Subject: New U-Scan Leveling Foot

Overview

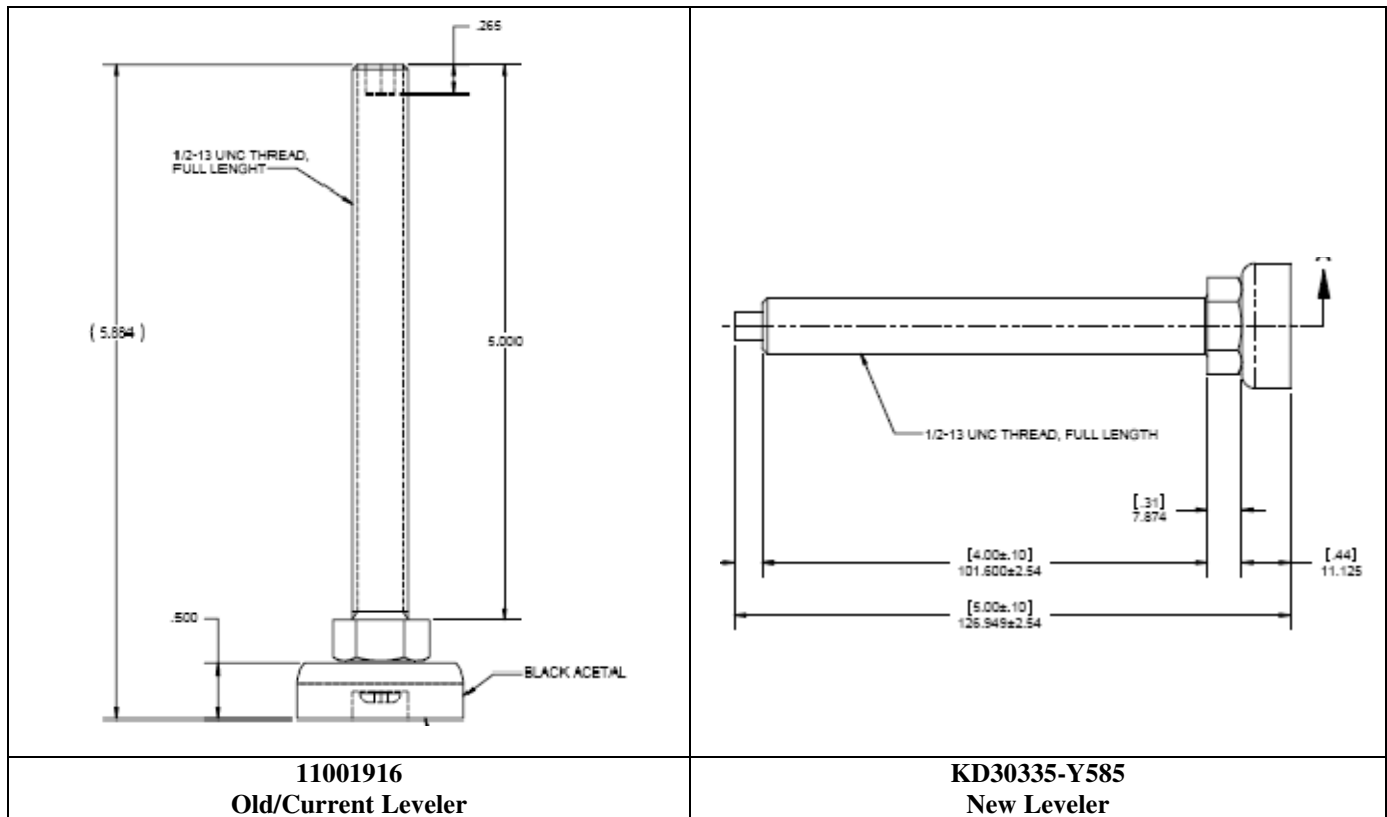
In order to meet the new 2010 ADA compliance standards, the leveling feet on the U-Scan is being changed. The new leveling foot allows the U-Scan to be lowered closer to the floor. It is however, also shorter in length (4" instead of the current 5" length). The new Leveler also has an external Hex shaft for easier adjustment using a socket rather than the Hex Allen Wrench required on the old/current Leveler.

If the distance from floor to top of U-Scan Chassis threaded hole is 4" or less, then either leveling foot can be used. If the distance is over 4" and the entire U-Scan cannot be lowered to allow the new leveling foot to fit, the current foot will be required. There is no anticipation that this will ever occur but must be considered. For this reason a small stock of the old/current leveling feet should be retained and be available (with Tech Support approval) for that rare case.

These new leveling feed will be cut into production of any Genesis unit shipped in 2010 or later. Bag Scales, Carousels, and Belted Units will continue to use the old/current Leveler until stock is depleted then will also use the new Leveler.
